REGIONAL REVIEW NOTIFICATION

ARC REVIEW CODE: R1803061

Name of Proposal: Gardner 42 (DRI 2775)

**GARDNER 42 DRI
Henry County
Natural Resources Group Review Comments**

DRI PLAN
SCANNELL PROPERTIES
LOCUST GROVE, GA
DRI #2775 - GARDNER 42 SITE, FEBRUARY 23, 2018

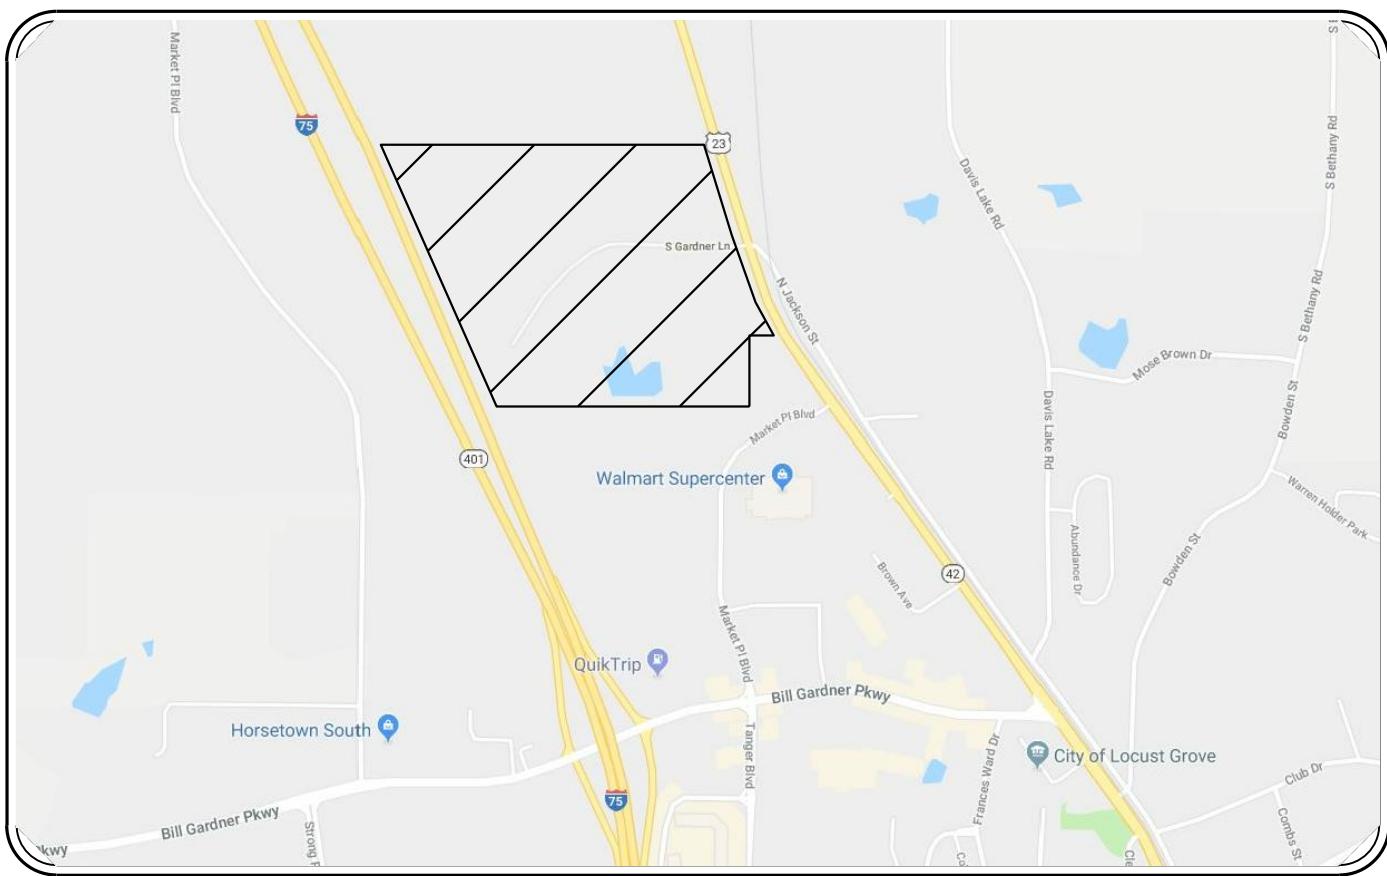
Neither the USGS coverage for the project area or the submitted site plan shows any perennial or intermittent streams on the property. Any unmapped streams on the property may be subject to the Locust Grove Stream Buffer Ordinance as well as the 25-foot State Erosion and Sedimentation Act buffer. Any other waters of the state on the property would be subject to the 25-foot State Erosion and Sedimentation Act buffer.

No stubouts are proposed. Vehicles will have to access adjacent parcel by SR 42.

The development doesn't propose internal or external sidewalk facilities.

The two driveways proposed allow for shared access and maneuvering of vehicle and freight traffic .

The development should consider constructing pedestrian facilities such as sidewalks on site frontage along SR 42.
